SI B31 06 14  
Front Axle

## Front Axle Noise when Turning at Low Ambient Temperatures

This Service Information bulletin supersedes SI 31 06 14 **dated August 2015**.

I01 (i3 and i3 REx)	 Produced from 8/31/13 to 5/5/15
---------------------	---

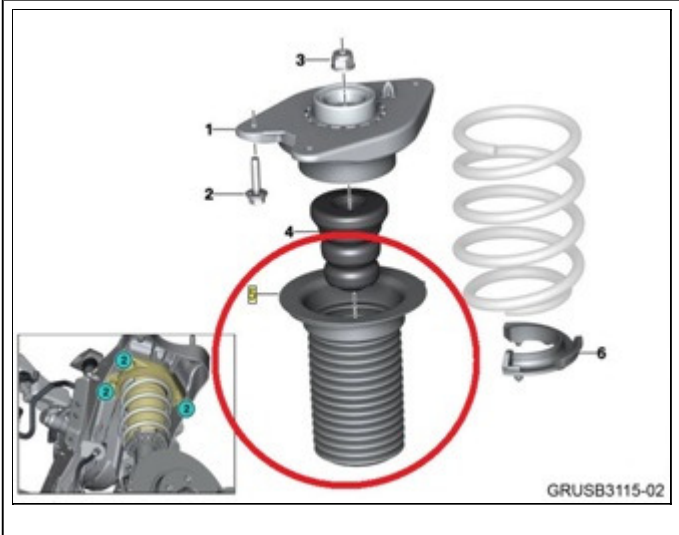
A grating and/or squeaking noise from the front axle occurs when turning at low speeds or idle.

The noise is most noticeable at low temperatures (approx. 32 degrees F), but not unusual at higher temperatures and after driving.

Friction between the spring pad and the strut upper support bearing is causing the noise.

<p>Replace both upper spring pads with guard tube of the front spring struts. Refer to repair manual REP 31 31 031. The improved upper spring pads can be identified by an index 03 following the part number. <b>P/N 31 33 6 852 223-03</b></p>
---	--
